THE
NATIONAL
BOARD
OF BOILER AND
PRESSURE VESSEL
INSPECTORS

SUBCOMMITTEE ON INSTALLATION

Minutes

*Meeting of July 18, 2012
Columbus, Ohio*

Figure 1

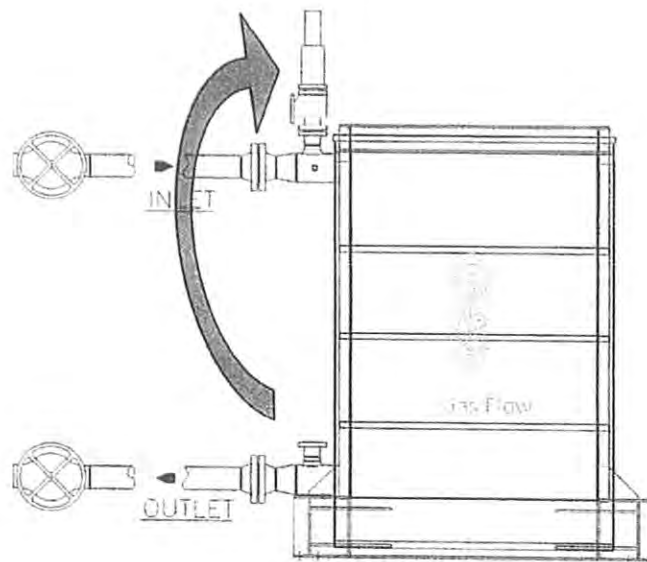
<u>Name</u>	<u>Document</u>	<u>Comment</u>	<u>Date Created</u>
Donald Patten	<u>NB11-2001</u>	I looked at ASME 2007 edition Addenda 2009 and found nothing stipulating the location of a relief valve for isolable economizers. Please see a copy of the attached from said edition. If anyone can point me in the direction of where I can find this information I would greatly appreciate it.	03/27/2012
Donald Patten	<u>NB11-2001</u>	I responded with a copy of the attached from ASME. I could not find any stipulation for isolable economizers relief valve location. I had asked Mr. Pillows to please provide this information so I could review.	03/27/2012
Donald Patten	<u>NB11-2001</u>	I look at ASME Section 1 2007 Addenda 2009. I could not find any stipulation of relief valve location. See attached copy of PG 67.2.6. If you could point me to the section that designates or stipulates installation location of a relief valve for an isolable economizer I would greatly appreciate it.	03/27/2012

Paul Edwards		I would like to see a response to Mr. Pillow's concern.	03/26/2012
James Pillow		Jpillow 3/21/12 I disapprove because the proposal is an attempt to re-write ASME Section I rules that already address mounting of pressure relief valves. Section I does not allow the mounting of the valves "as recommended by the Manufacturer". Keep in mind that Part 1 of the NBIC does not overrule the Section I rules.	03/21/2012
Donald Patten		Mr. Richardson, I queried Mr. Olson at Victory Energy and below is his comments: Locating the PSV at the outlet without specifying an outlet location does not support an idea that the outlet of an isolated economizer is the strategic location for the PSV. The commenter is correct that, when the economizer is isolated, rarified fluid will immediately begin to collect at the upper areas. Due to the fact that the PSV can be set very close to operating pressures, the time element may not always come into affect. Anyway we look at it, allowing or the PSV location to be determined by the Designer is most beneficial. Regards, David Olson	03/21/2012

This is more of an editorial comment, but I believe it would be better stated below; The safety valve shall be installed in a location either recommended by the manufacturer, or if no recommendation is provided shall be located as close as practical to the economizer outlet.

Figure 4.6.xxx Carbon Dioxide Phase Diagram

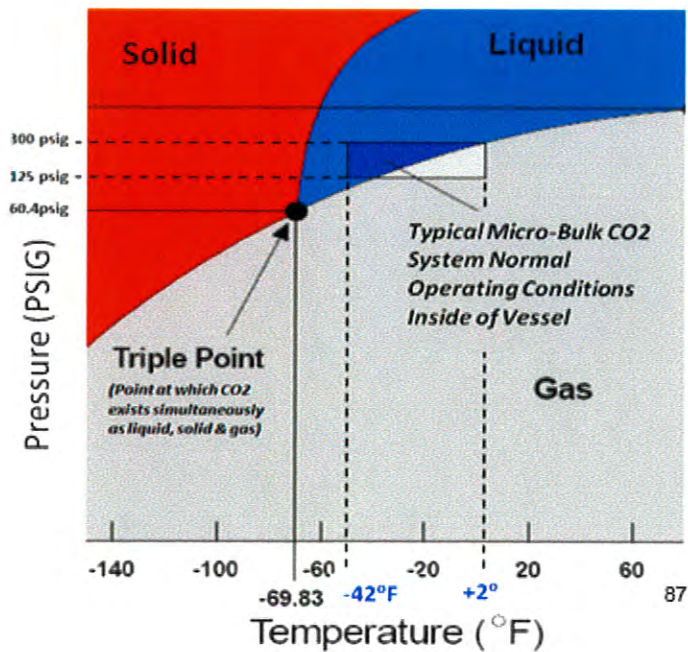
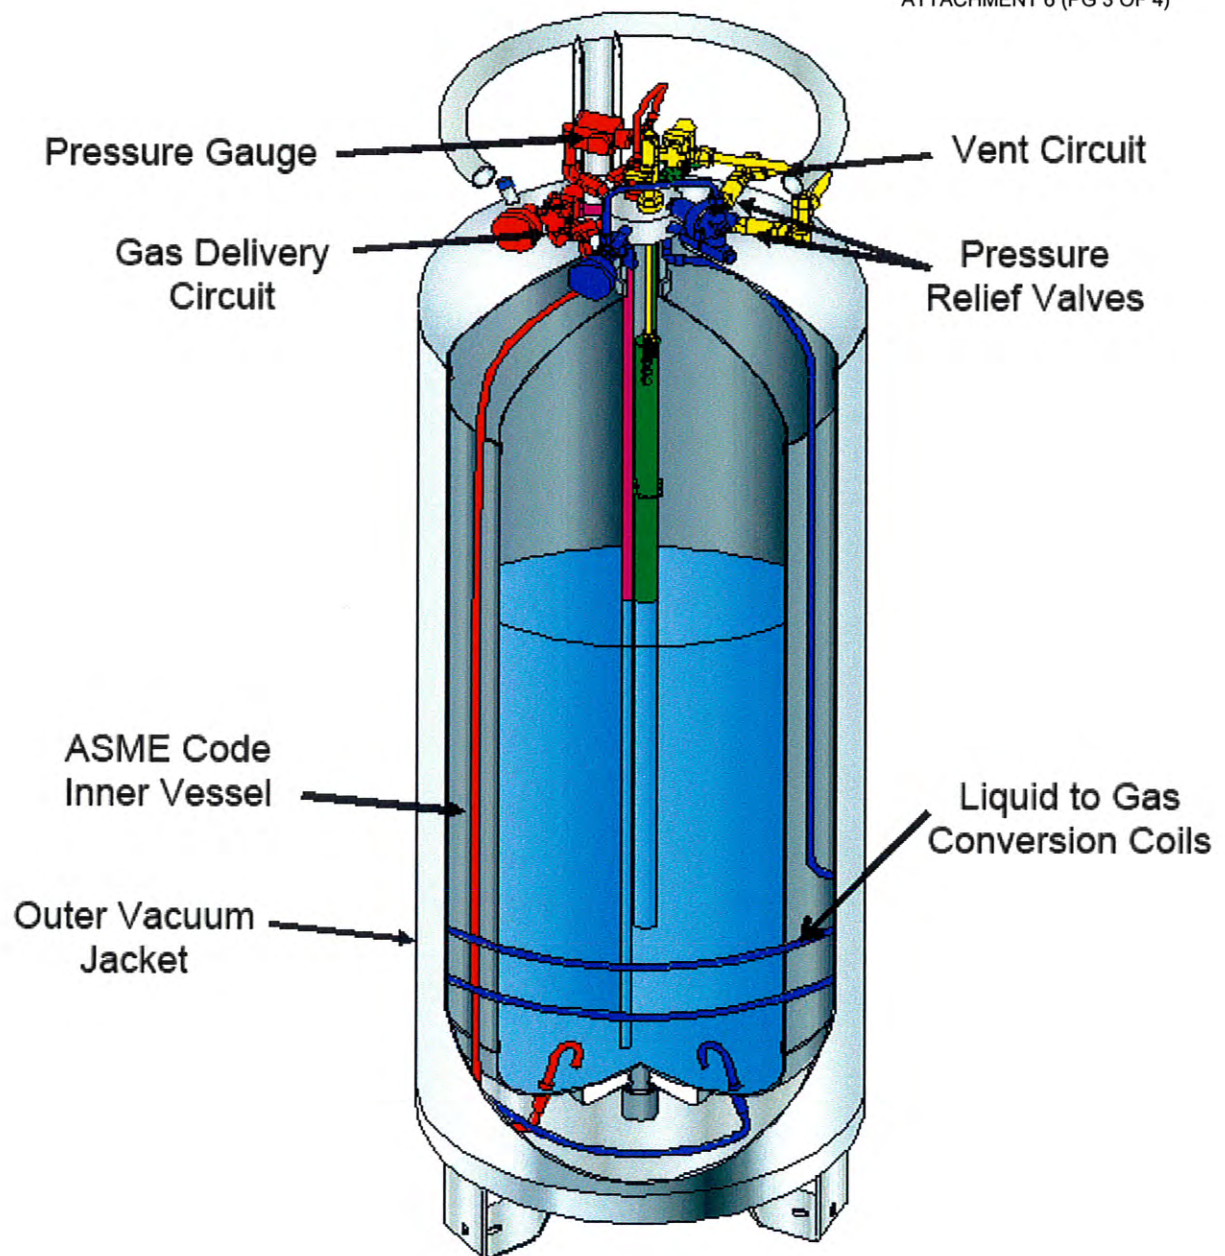
1. The phase diagram included as part of the proposal is not consistent with publically available data. For example, the published triple point is -56.6°C (-69.88°F) at 5.11 atmospheres (60.417 psig) (1 atm = 14.7 psia). Four significant figures of precision requires the change.

2. The figure shows an intersection at 125 psig and -42°F with no corresponding explanation in the text.

Alternative: If the figure is changed to -70.0°F (three significant figures consistent with 60.4), I would withdrawn my negative.

Suggested solution: delete the axis labels and intersection lines or provide and explanation in the text.
